<div>ENGINEER'S SEAL</div> <div></div> <div>12/1/14</div> <div>DAVID SOULE P.E. #14522</div>	<div>AMERICAN TOYOTA</div> <div>GRADING AND DRAINAGE PLAN</div> <div></div> <div>Rio Grande Engineering 1806 CENTRAL AVENUE SE SUITE 201 ALBUQUERQUE, NM 87106 (505) 872-0999</div>	DRAWN BY WCWJ
		DATE 12-01-14
		21403-LAYOUT-1-25-14
		SHEET #
		JOB # 21403

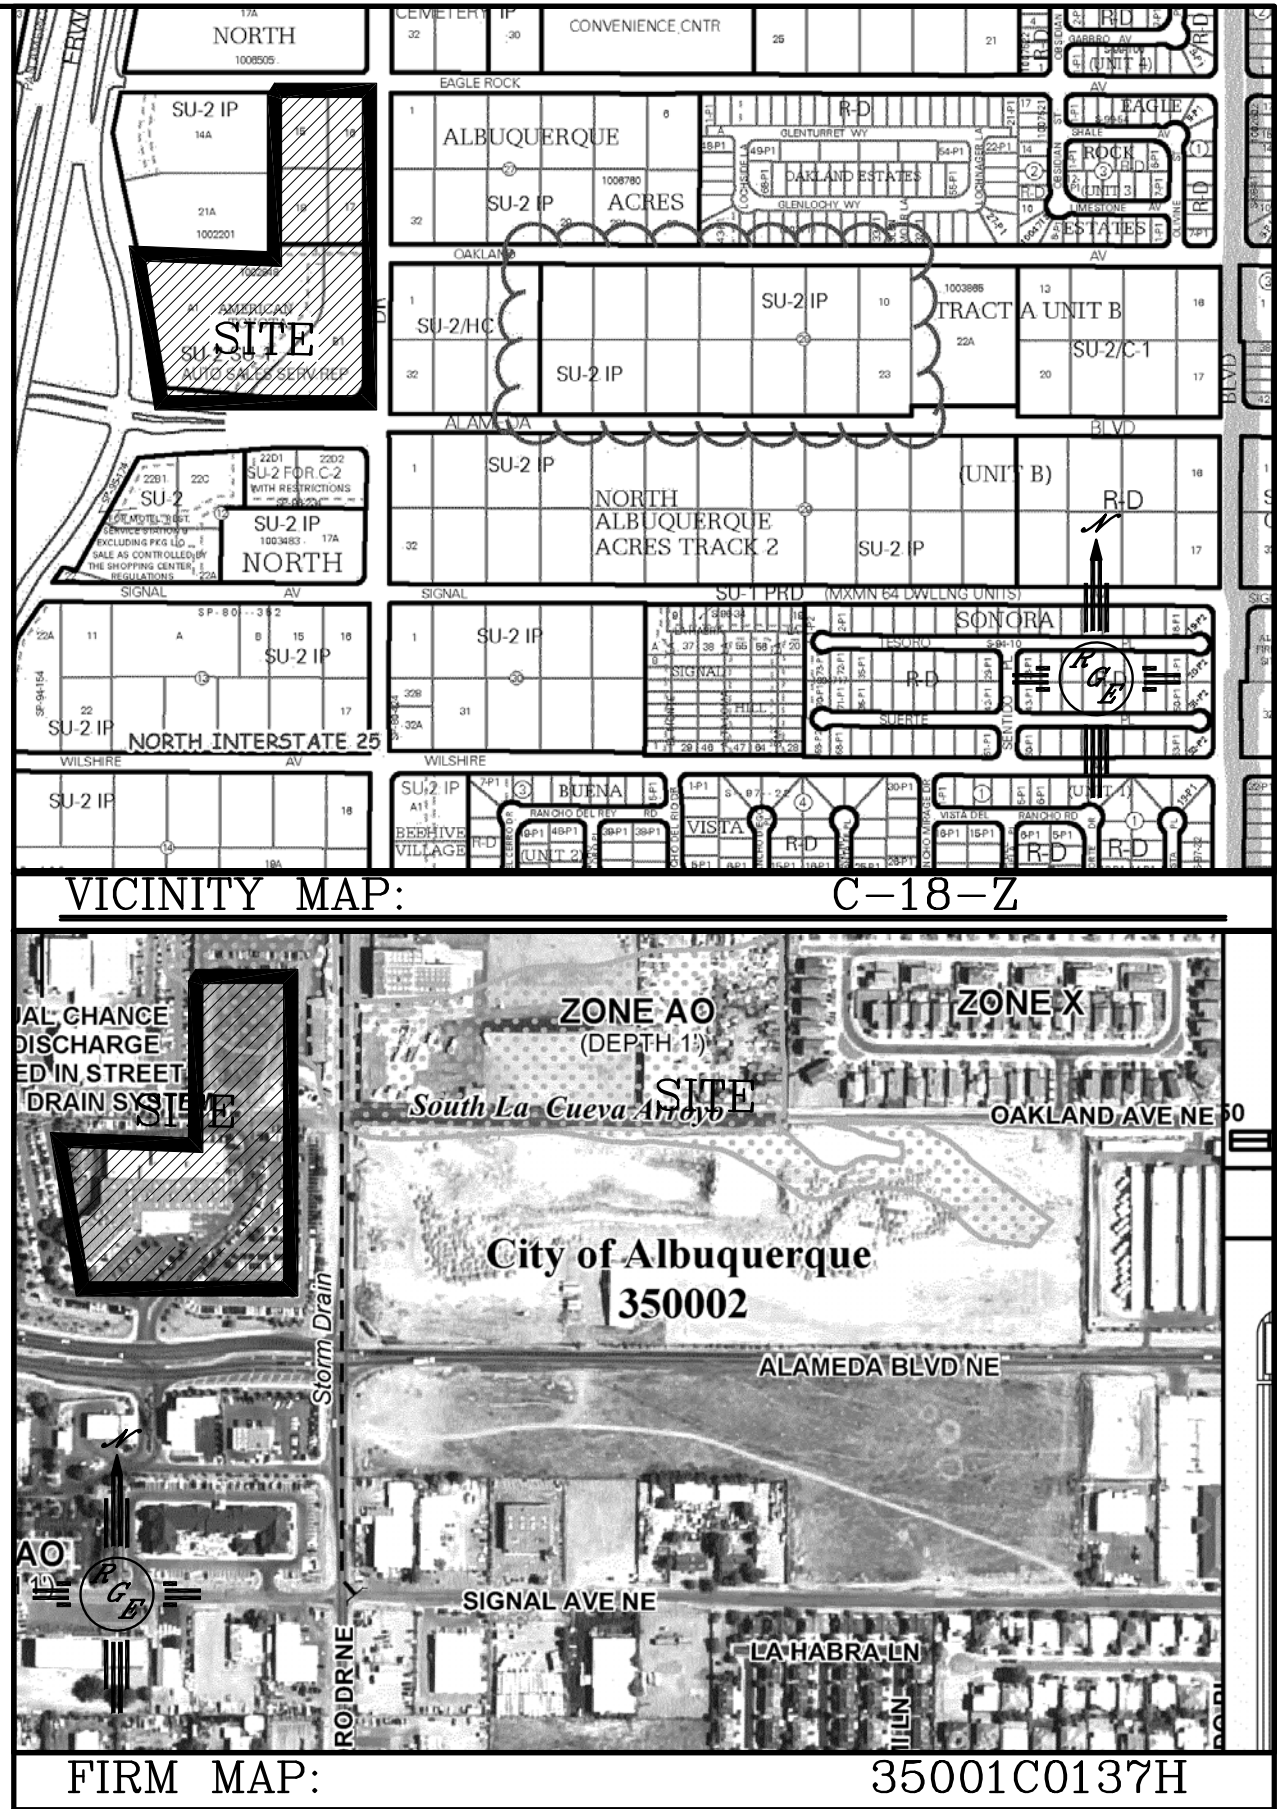
THIS IS FINAL GRADING PLAN, ADD MORE SPOTS
